# Exploration of SCMR Limits in 802.3ck D2.3

Mau-Lin Wu, MediaTek

For IEEE 802.3ck

## Background – New SCMR (min) in 802.3ck D2.3

# Limited Values of Components of CM Voltage

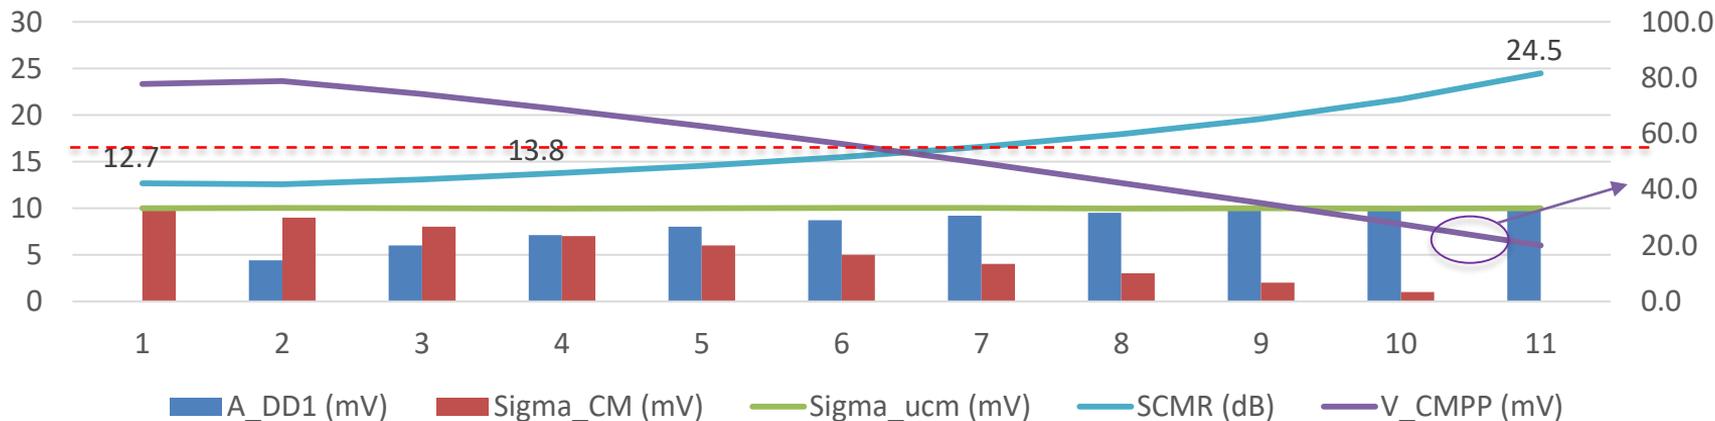
- ❑  $\sigma_{ucm} = 10$  mV aligned with [mellitz 3ck 01 0921](#)
- ❑ Large value of  $A_{DD2}$  doesn't impact RX, but will fail SCMR spec → two options
  - ❖ Option 1 – reduce SCMR limit by considering  $A_{DD2}$  component
  - ❖ Option 2 – define CM specs for correlated & uncorrelated ([mellitz 3ck 01 0921](#))

SCMR with  $\sigma_{ucm} = 10$  mV,  
 $A_{DD1} = \sigma_{CM}$ , by sweeping  $A_{DD2} = 0 \sim 10$  mV

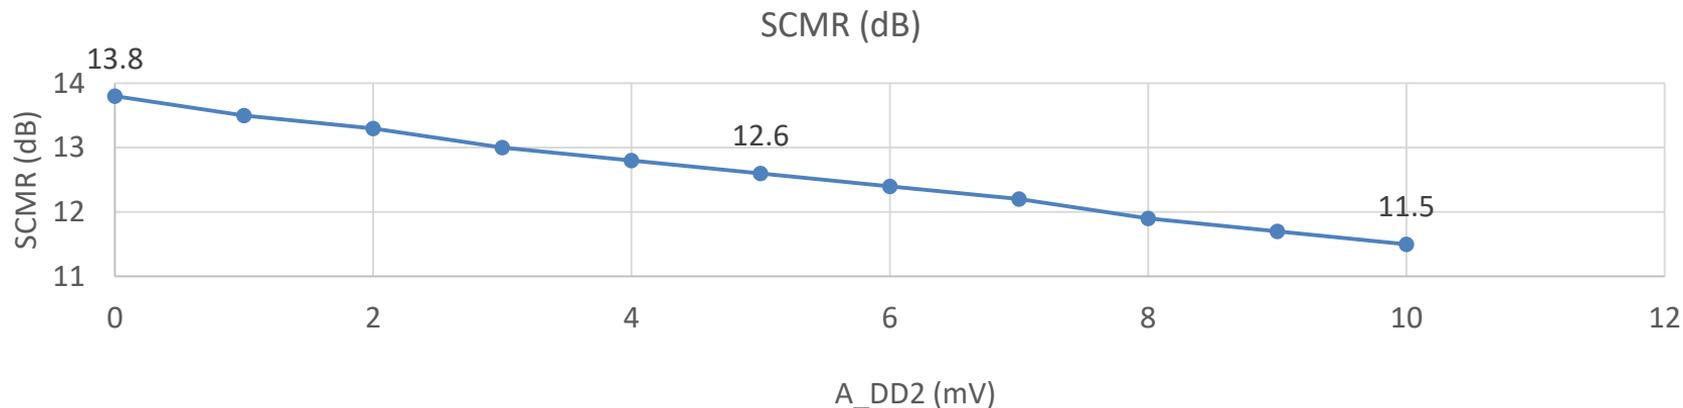
- ❑ Although  $A_{DD2}$  doesn't have big impact to RX, but contributes a lot to reduce SCMR value
  - ❖ Reduces SCMR with 0.8 ~ 1.7 dB for  $A_{DD2}$  in 5 ~ 10 mV
- ❑ It may change too much to D2.3 if excluding  $A_{DD2}$  in SCMR or defining CM specs for correlated & uncorrelated ([mellitz 3ck 01 0921](#))
  - ❖ Propose to further reduce SCMR spec limit to reflect this issue, to say 13 dB
